# **CIVIL ENGINEERING REPORT INCORPORATING WATER CYCLE MANAGEMENT STRATEGY**

## **SSD 9522 (MOD3) MAMRE ROAD & SOUTHERN LINK RD. KEMPS CREEK NSW**

<b>Project Title</b>	The Yards Estate Kemps Creek “SSD9522 Mod3”
<b>Document Title</b>	Civil Engineering Report Incorporating Water Cycle Management Strategy
<b>Project No.</b>	Co13362.00
<b>Description</b>	SSD MOD3 report for future industrial estate
<b>Client Contact</b>	Mr Paul Solomon, Frasers Property Mr Stephen O’Conner, Altis

**Figure 4.3. Bakers Lane, Future SLR and New Access Road Intersection Arrangement**

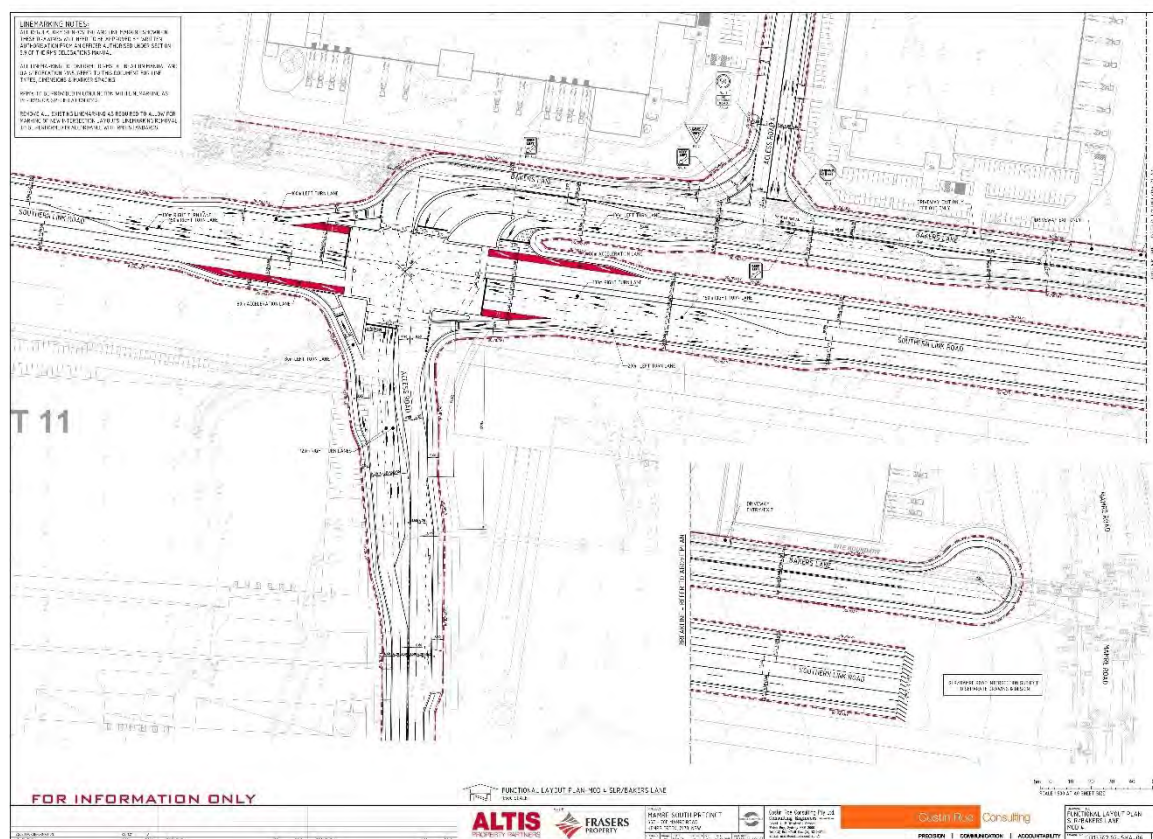
No.	Comment	CRC Response
<p><u>SLR layout (CO13362.01-SK30-A):</u></p> <p>It is noted that the signalised intersection design has been provided to understand how the ultimate road layout will work with the proposed layout for the Lots 1-4 and will not be constructed under this SSDA. However the design still needs to be realistic in order to ensure that adequate land is reserved for the ultimate layout. In this regard, following comments are required to be addressed as part of this Modification to SSDA</p>		
1a	TfNSW would require the signals to be designed as double diamond. This allows for better flexibility during time of heavy congestion.	The design allows for the ability for double-diamond arrangement to be introduced in phasing. The ASON TIA has tested single and double diamond and notes that due to the low volume of traffic from the north, compared to that from the south that the double-diamond arrangement has

No.	Comment	CRC Response
		lower efficiency than that as designed.
1b	Swept paths are required for further review. It is difficult to comment on the high angled entry without seeing the swept paths. Questions are raised as to whether a B-double could achieve the angles at the norther leg.	Refer to drawings <b>Co13362.00-SK4-06</b> to <b>SK4-09</b> included in <b>Appendix A</b> for swept paths of design and check vehicles.
1c	North leg: <ul style="list-style-type: none"> <li>The high angle of the north leg reduces visibility to the signals and is considered not acceptable</li> <li>The major movement will dominate the other movements which raises efficiency issues.</li> </ul>	Measures can be introduced to address the visibility concerns to an acceptable level in detail design phase. These could include such measures as gantry traffic signals, early warning systems or other acceptable systems.  Refer to ASON TIA which confirms acceptable efficiency for the intersection based on the proposed concept arrangement.

1d	Minimum distance required between turning vehicles is 2 metres – clarify distance	Clearances of greater than 2.0m to opposing vehicle paths has been achieved. Refer to drawings in <b>Appendix A</b> .
1e	It is unclear why a bus jump was not provided for the eastbound lane	A bus jump has been included. Refer to drawings in <b>Appendix A</b> .
1f	Why is there a chevron section on the south leg. This is not supported.	A chevron is proposed on the left turn out from Bakers Lane to the SLR only. This is provided to direct passenger vehicles in a smaller throat width, whilst allowing for larger vehicles to traverse their larger swept paths. Chevrons are in accordance with Austroads Design Guidelines.
1g	The west pedestrian leg extends over 7 lanes of traffic. There needs to be consideration of a staged crossing. Alternatively if there is low pedestrian movements, the median is to be wide enough to store a person and to include a push button. This should be provided on the west, and east leg of the intersection. This will require a larger footprint and should be identified now as the current arrangement will not be supported.	Pedestrian refuge has been included in the concepts to allow for staged crossings if required.

1h	North leg - The angle of the left turn slip lane creates vision impairments to the pedestrian signals and not accepted on safety ground.	Sufficient visibility is available in the concept layout. If additional measures are required to improve safety these could be introduced in detail design phase.

No.	Comment	CRC Response
1i	A modelling memo needs to be provided with the signal design to understand what steered the design.	Refer ASON TIA
TfNSW suggests that investigation be undertaken into the following design considerations:		
1h	extending the north leg straight north as opposed to following the current bakers lane alignment. This will remove most of the abovementioned concerns with regards to the obscure angle of north leg.	Consideration to extending the north leg has been made however this results in unacceptable commercial changes which do not suit the requirements or use of the land.
1k	Could the north leg left slip be relocated away from the signal as a separate uncontrolled intersection? If this is considered there will need to be adequate distance from the SLR/Mamre Road intersection so as to not have lane changing issues close to signals.	Relocation of the northern slip lane could be considered as part of future more detailed assessments. The concept shows that an intersection solution with the SRL is available, if the SLR is to be developed in the future.
